TECHNICAL NOTE

#22

Figure 1

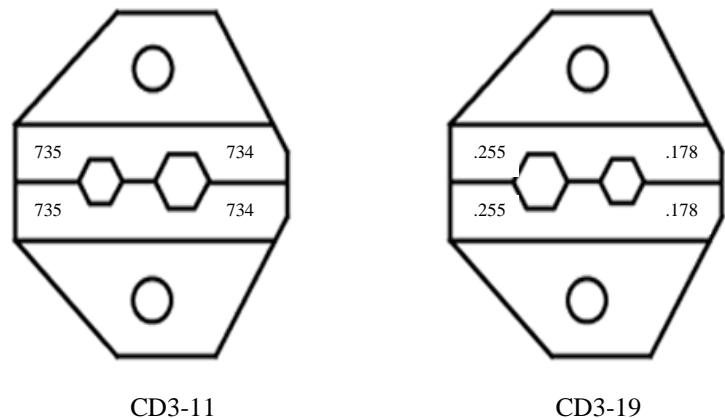
The "Flip Flop" dies are an **improvement** to our 734/735 series of dies; CD3-11, CD3-15 and CD3-17. The term "Flip Flop" is somewhat of a misnomer. The actual difference is that the smaller 735 hex cavity was moved closer to the fulcrum of the tool, and the larger 734 hex cavity was moved away from the fulcrum, or swapped. If you compared a CD3-11 die and a "Flip Flop" CD3-19, you can easily see difference (figure 1). The advantage is that it increases the amount of closure force applied to the smaller 735 hex cavity, increasing the retention performance, without increasing the tension of the tool. Depending on what cable is used, the proficiency of the assembler, the tension of the tool, etc., the difference can be substantial. If an installer has a tool that has a less than desirable crimp force, this may be the difference between the connector passing a retention test, rather than failing one .

The "Flip Flop" dies come in a couple of different styles and part numbers. The CD3-19 embosses the hex dimensions .178 and .255. You also have the CD3-19 special – 010-0129-XX – that embosses 734 and 735, as well as the company's initials. There is also the CD3-17 special -- 010-0118-XX that embosses the hex dimensions .178 and .255, as well as the company's initials, and the CD3-18 special – 010-0118-XX – that embosses the hex dimensions .178 and .324, as well as the company's initials.
